ASSESSMENT REPORT
Invincible Colliery
Southern Extension Modification
(07_0127 MOD 5)

Assessment Report
Section 75W of the
Environmental Planning and Assessment Act 1979

November 2017

Figure 8: Proposed Hillcroft Biobanking Site

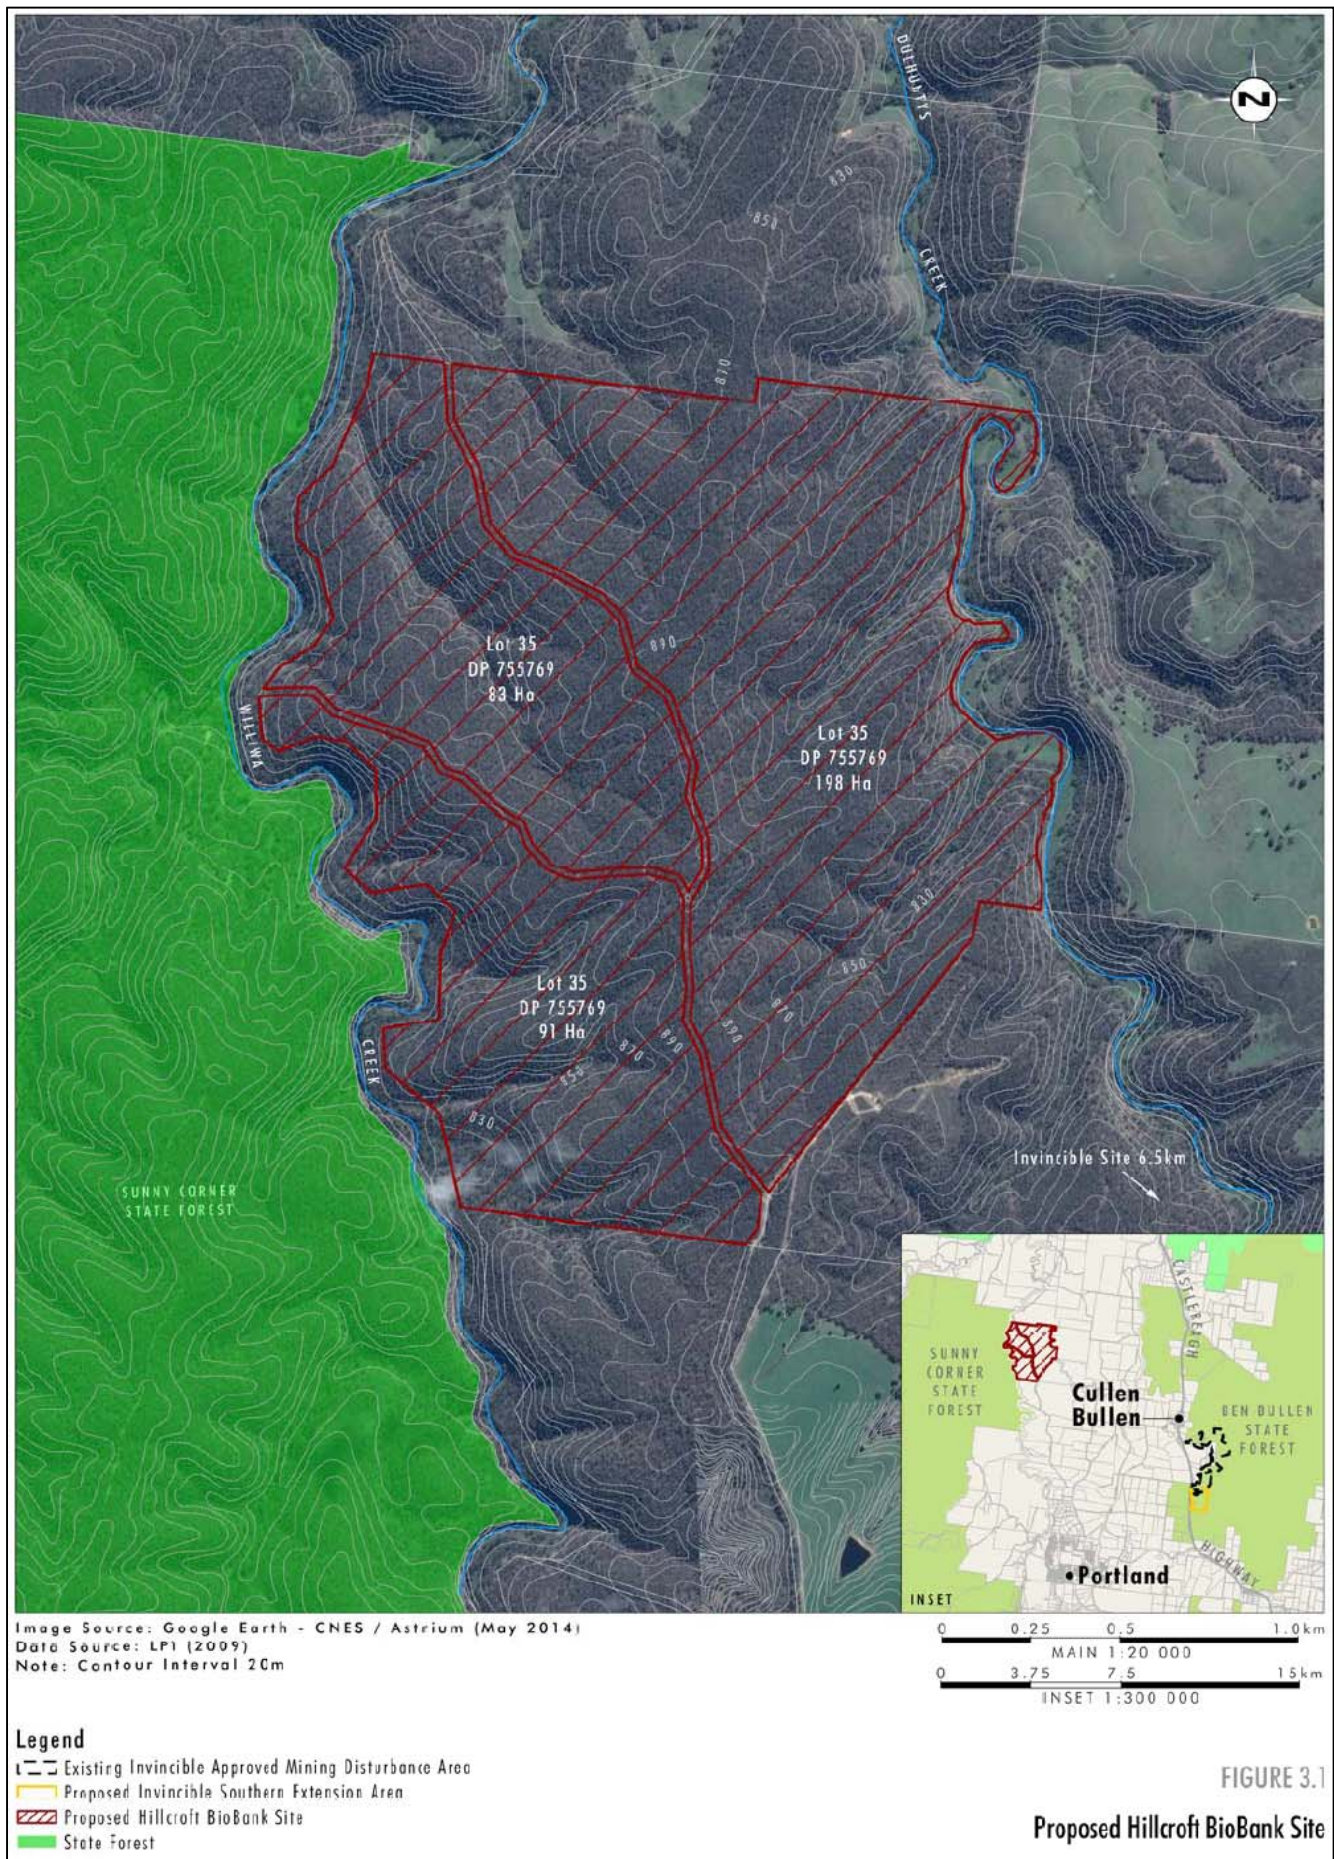
The proposed Hillcroft Biobanking Site would be used to meet the ecosystem and species credit liabilities of the modification application. The Hillcroft Biobanking Site is approximately 368 ha in area and is located approximately 5 kilometres north west of the Invincible mine (see **Figure 8**).

Figure 10: Water Management System Catchment

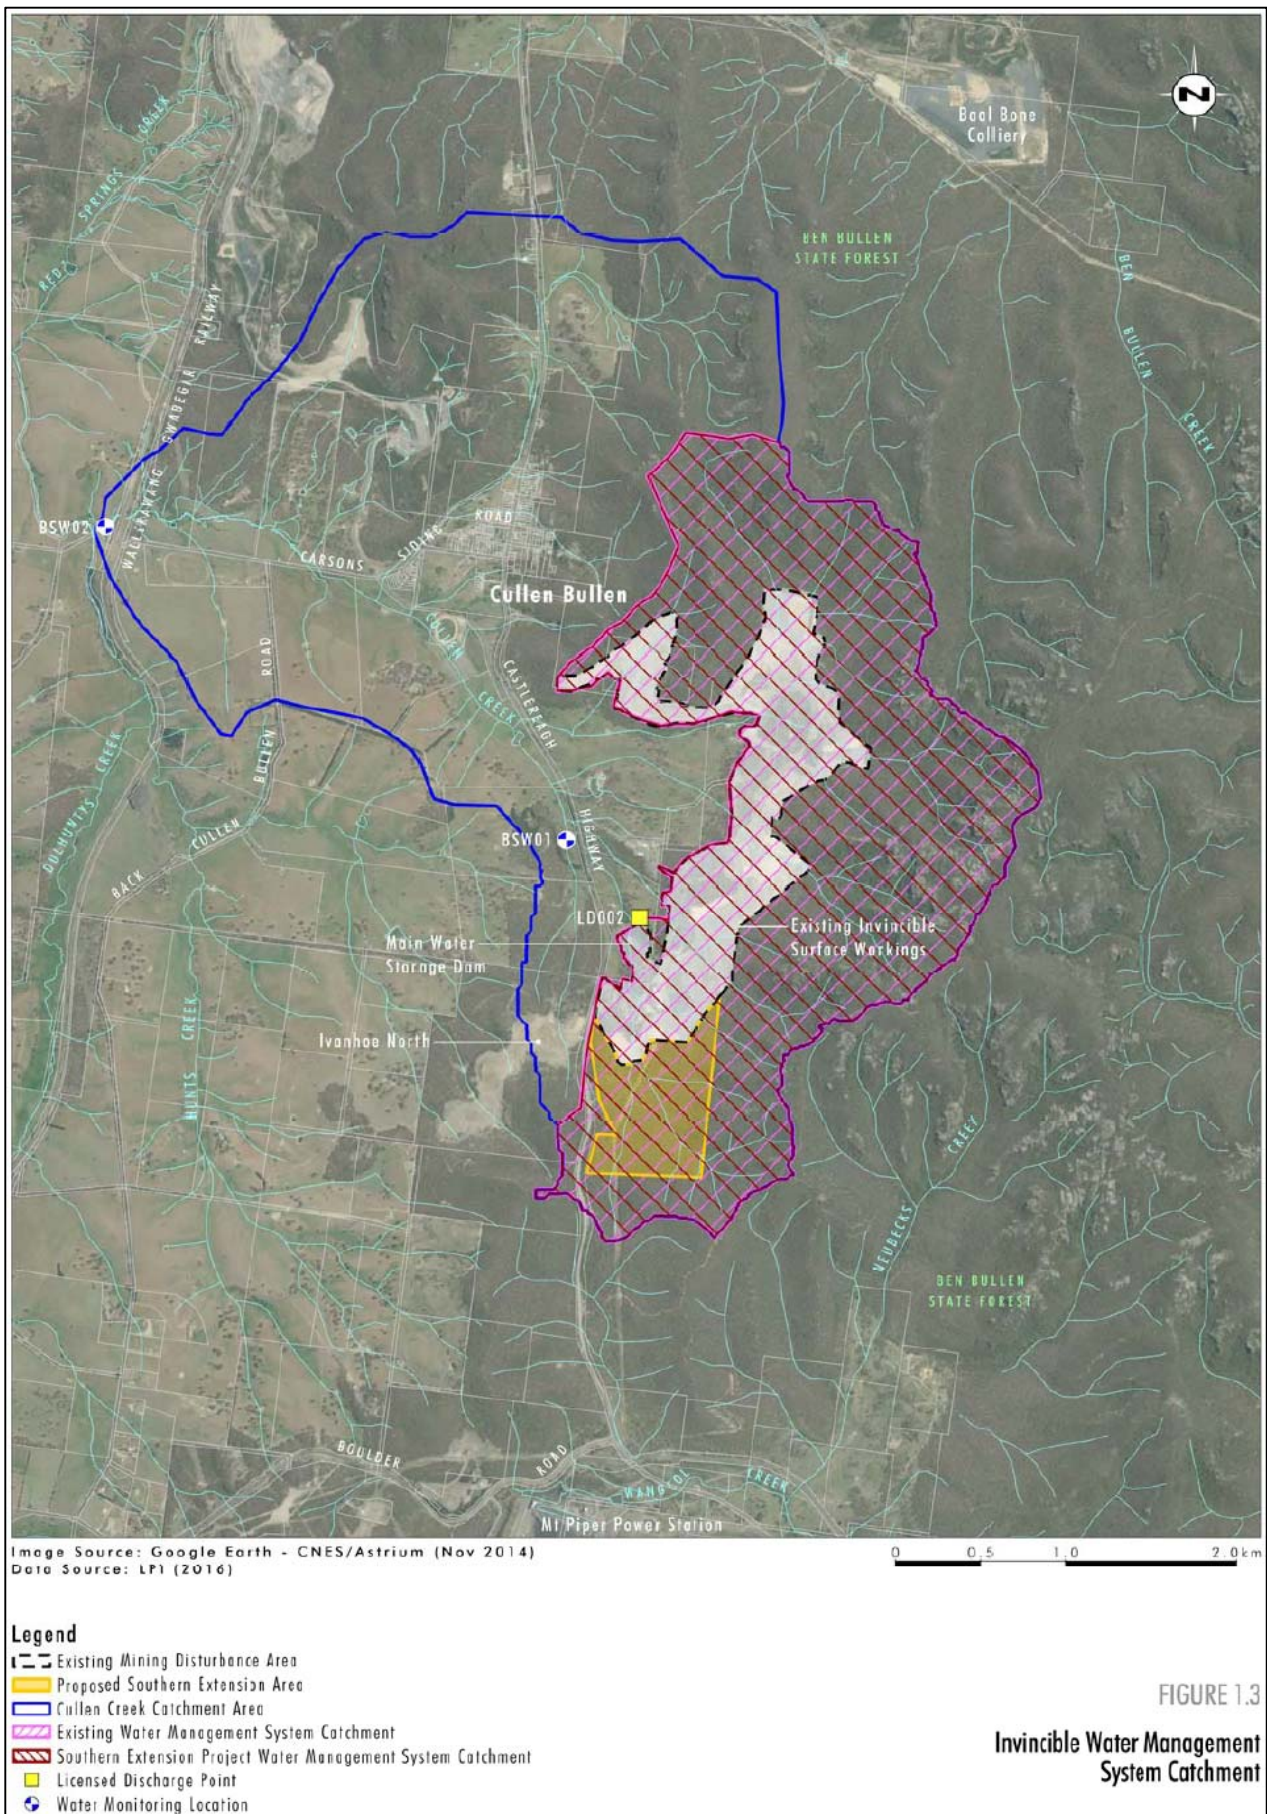
The existing operations and the Southern Extension Area are located within the Cullen Creek catchment. The proposed modification would not change the amount of surface water reporting to the dirty water management system as the Southern Extension area is located entirely within the catchment area of the existing water management system (see **Figure 10**).

The clean water diversions required by the existing water management plan at the Invincible Colliery do not operate in accordance with best practice. This results in some water from undisturbed areas reporting to the dirty water management system, rather than being diverted around the mine. Castlereagh Coal has not proposed to implement any additional diversion measures as part of the proposal due to topographical constraints associated with the construction of diversions and dams and the potential for additional biodiversity impacts.

Figure 11: Worst Case Noise Levels for Receivers 393 and 394

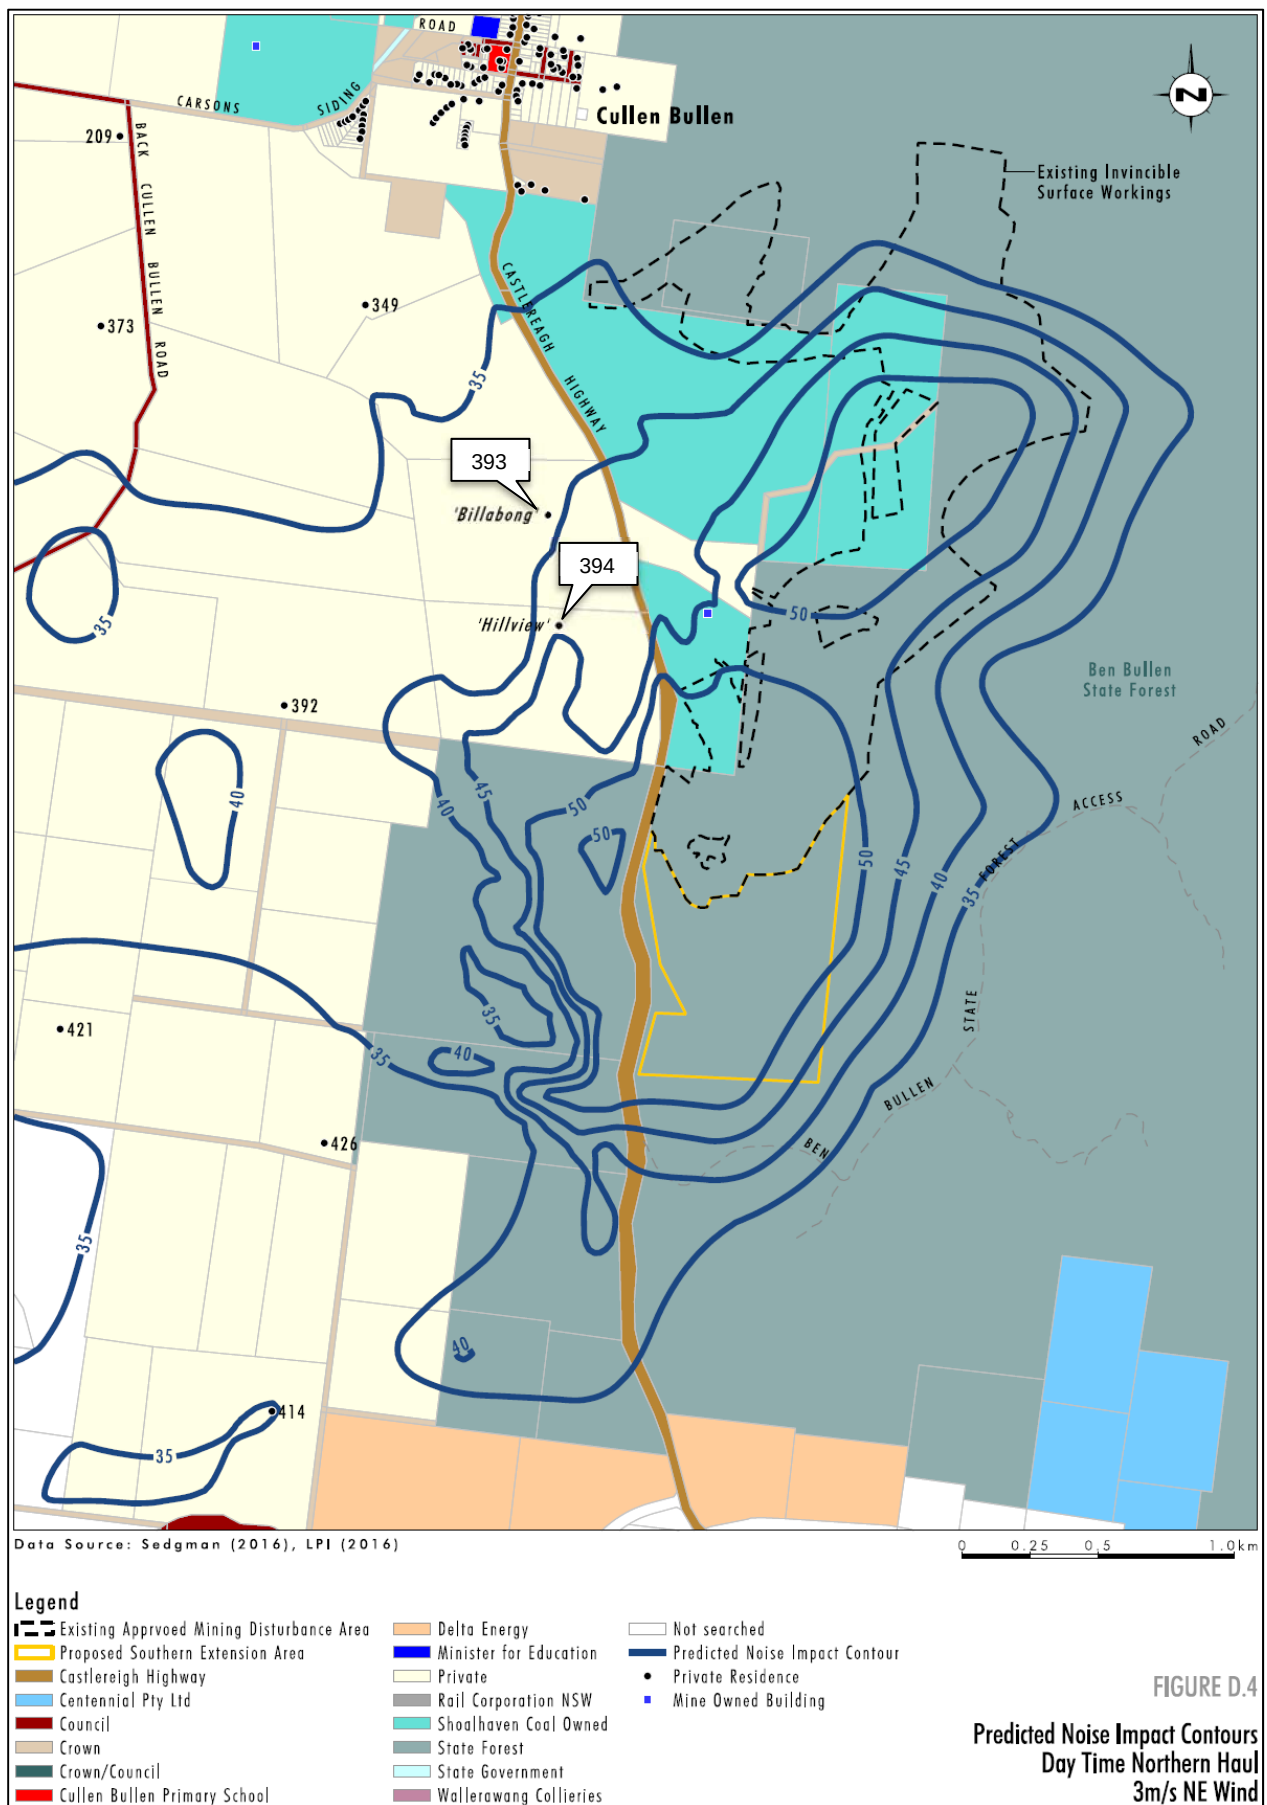
The worst-case noise levels are shown in **Table 5**. There would only be one exceedance of the Project Specific Noise Levels (PSNL) at one privately owned residence. Worst case noise levels at receivers 393 and 394 would coincide with the haulage of overburden to the eastern void. The noise contours associated with this scenario are shown in **Figure 11**.

Figure 12: Predicted Worst Case Air Quality Contours

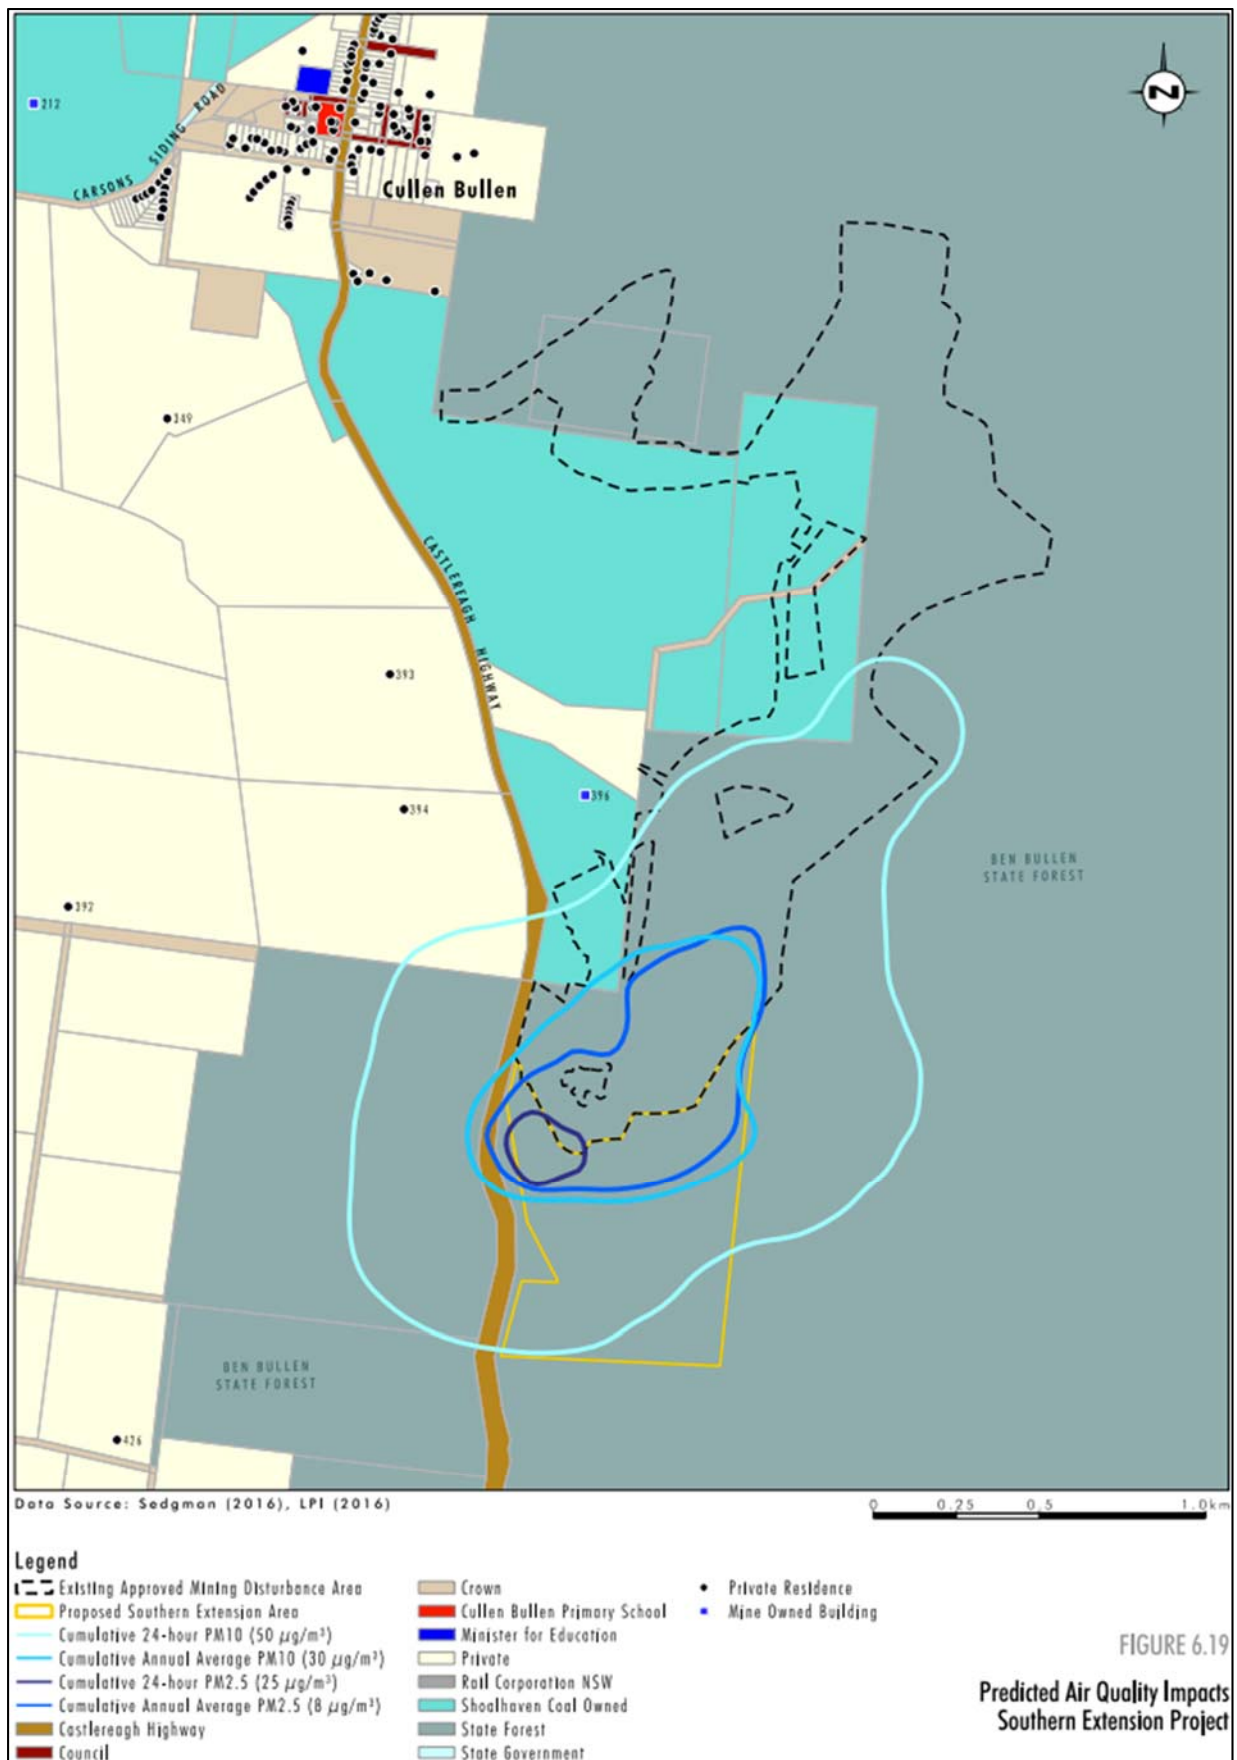
The EA includes an Air Quality Impact Assessment undertaken by Jacobs in accordance with the *Approved Methods for Modelling and Assessment of Air Pollutants in New South Wales* (EPA 2005). It modelled the predicted contributions from the proposal together with background levels for total suspended particulates (TSP), fine particle matter (PM_{2.5} and PM₁₀) and deposited dust. The predicted worst-case dust contours are shown in **Figure 12**.
